Public Works DEPARTMENT

*Proceedings of the Madras Government, Public Works Department,
31st March 1876.*

No. 570. Read the following letter from Lieutenant-Colonel J. F. FISCHER, R.E., District Engineer, Madura, to Major-General G. W. WALKER, R.E., Secretary to Government, Public Works Department, dated Teroomungalum, 10th March 1876, No. 4,579:—

Section of Back wall

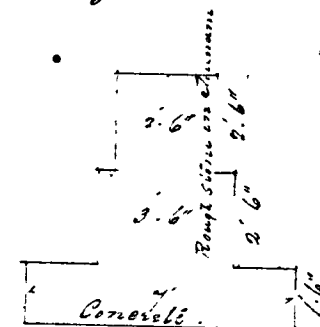
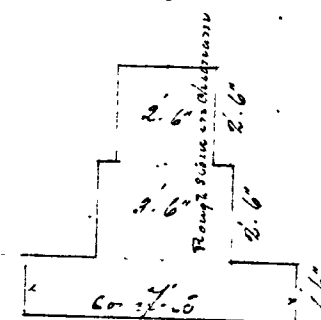
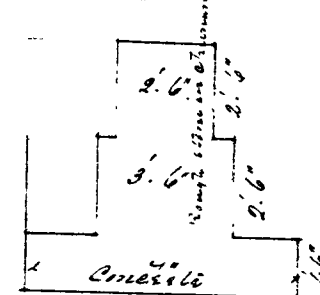
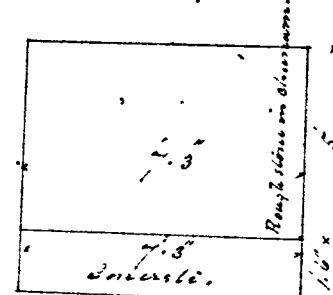
ADVERTING to G.O. of the 18th February 1876, No. 459, I have the honor to
2 Sections. forward sections of the Racquet Court wall
as proposed by myself, and as now

constructing on the revised design submitted by Colonel Roberts, it is quite true that officer allowed the *depth* of foundations I had proposed, but he decreased the spread or width of concrete all round 2 feet, and the general width of the wall at base 6 inches, increasing however the top step for the back wall 3 inches, and these circumstances are omitted in his report in G.O. of the 20th April 1875, No. 1,118.

2. My data were taken from my experience on the Godavery works, and as no failures had ever occurred in these, I am anxious not to be held responsible for structures constructed at variance with the design I had proposed.
